## Planning Commission Staff Report

| <b>Description:</b>  | <b><u>SMS Group (15320 Conway Road):</u></b> A Site Development Plan, Landscape Plan, Lighting Plan, Architectural Elevations and Architect's Statement of Design for a 0.93 acre tract of land zoned "PC" Planned Commercial District located on the south side of Conway Road approximately 500 feet west of its intersection with Chesterfield Parkway East (18S310348). |

| <b>Description:</b>  | <b><u>SMS Group (15320 Conway Road):</u></b> A Site Development Plan, Landscape Plan, Lighting Plan, Architectural Elevations and Architect's Statement of Design for a 0.93 acre tract of land zoned "PC" Planned Commercial District located on the south side of Conway Road approximately 500 feet west of its intersection with Chesterfield Parkway East (18S310348). |

Figure 5: Proposed Building Elevations

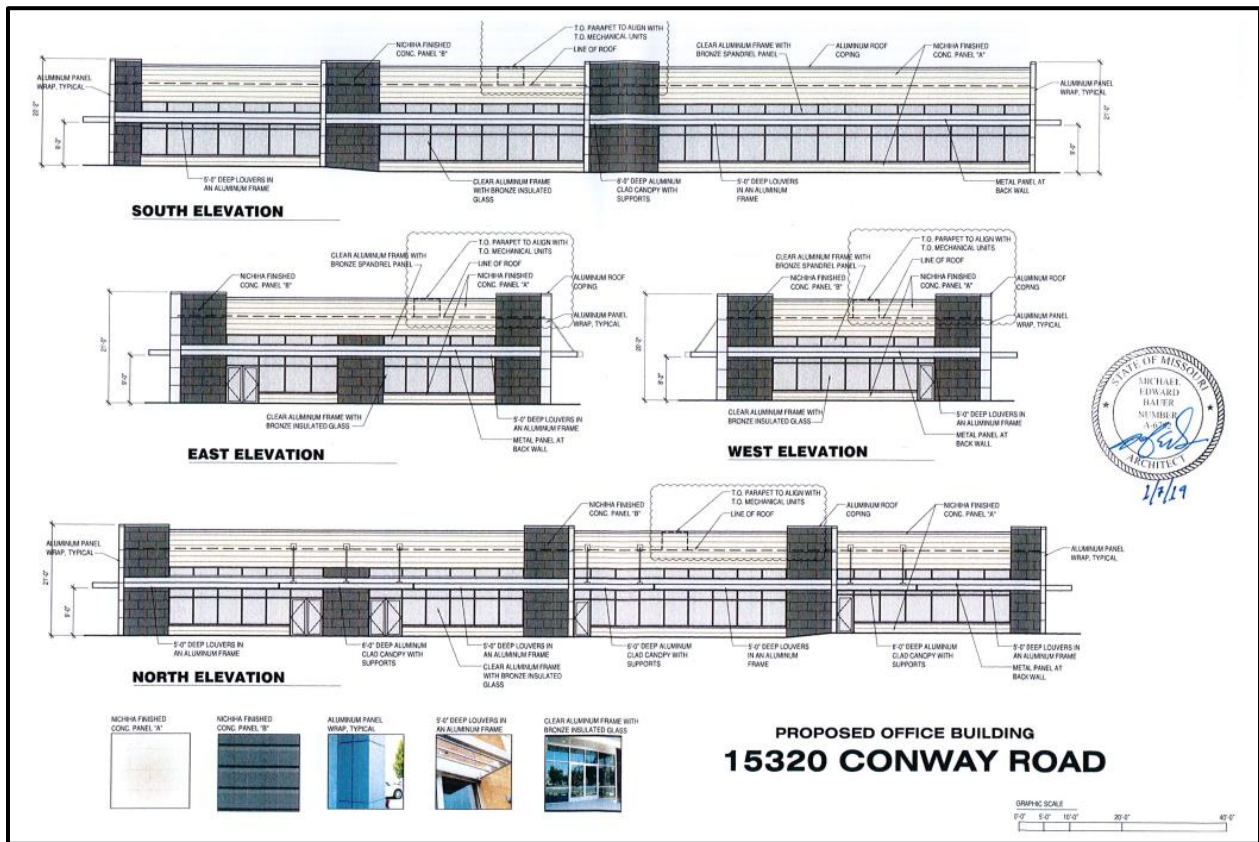
- **Due to the high visibility of the site, ensure mechanical equipment is placed to be adequately screened. The height of the roofline should be delineated on the building elevations.**

- **The color elevations and renderings should be revised to better reflect the materials being utilized, specifically the bronze windows.**

The building elevations have since been revised to include the requested information and depicts the roofline, mechanical unit location, and top of parapet walls.

Proposed exterior materials are labeled on the building elevations and sample images are included for each finish.

RETAINING WALL DETAIL  
SCALE: 3/8" = 1'-0"

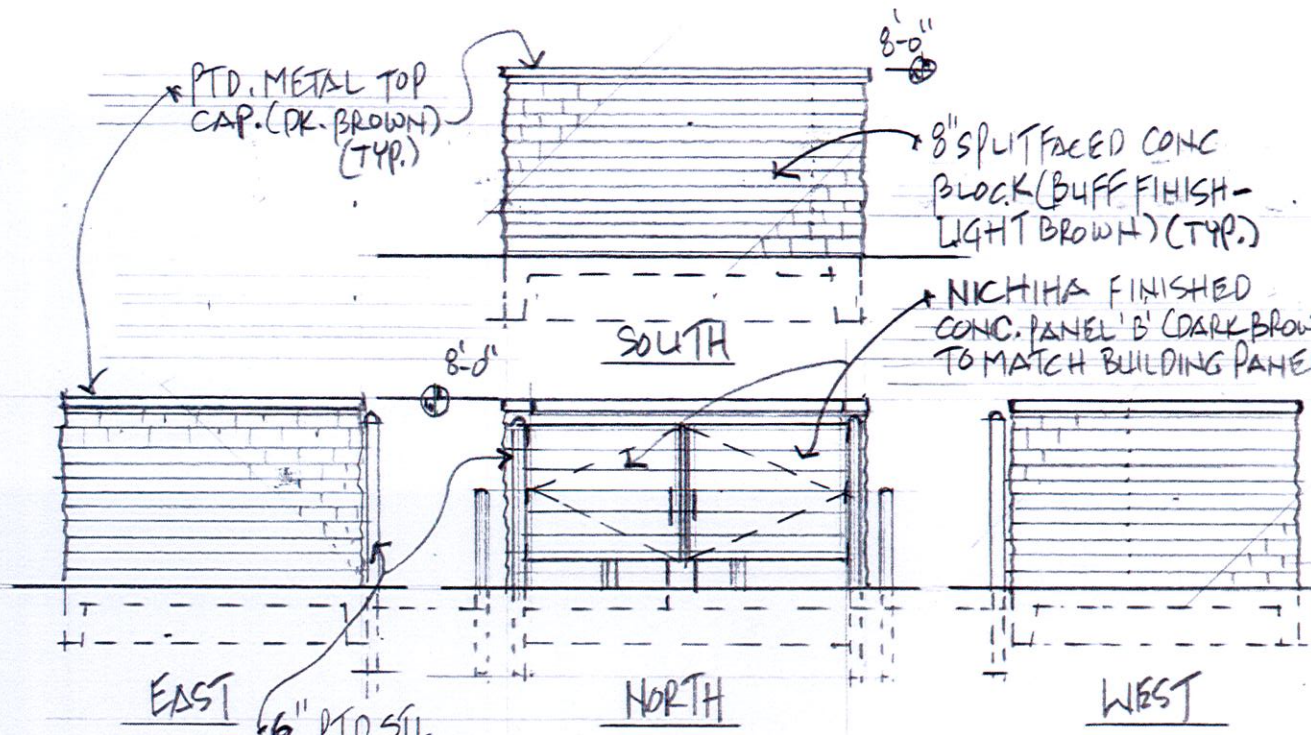
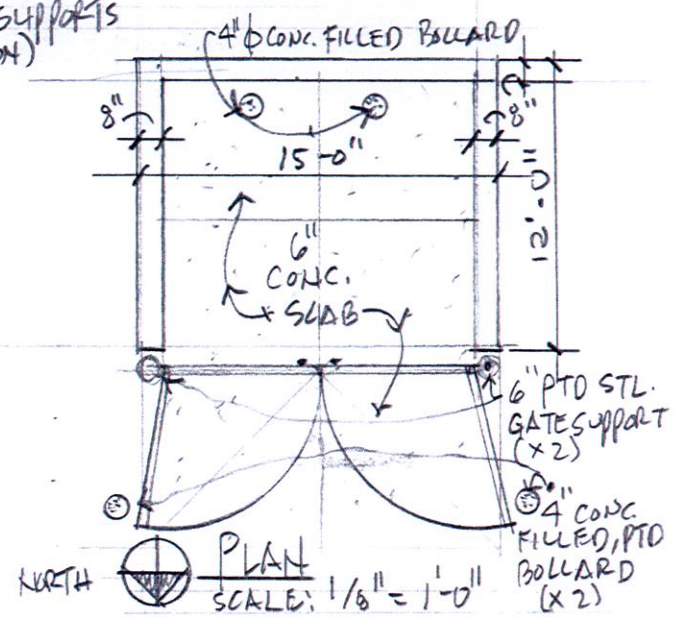
- **Provide details for the trash enclosure and the retaining walls.**

A detail for both the trash enclosure and retaining wall has since been provided and is included in the Staff Report packet. The trash enclosure is eight (8) feet in height comprised of materials complementary to the building, and the retaining wall includes segmental concrete block with a buff finish to match the trash enclosure.
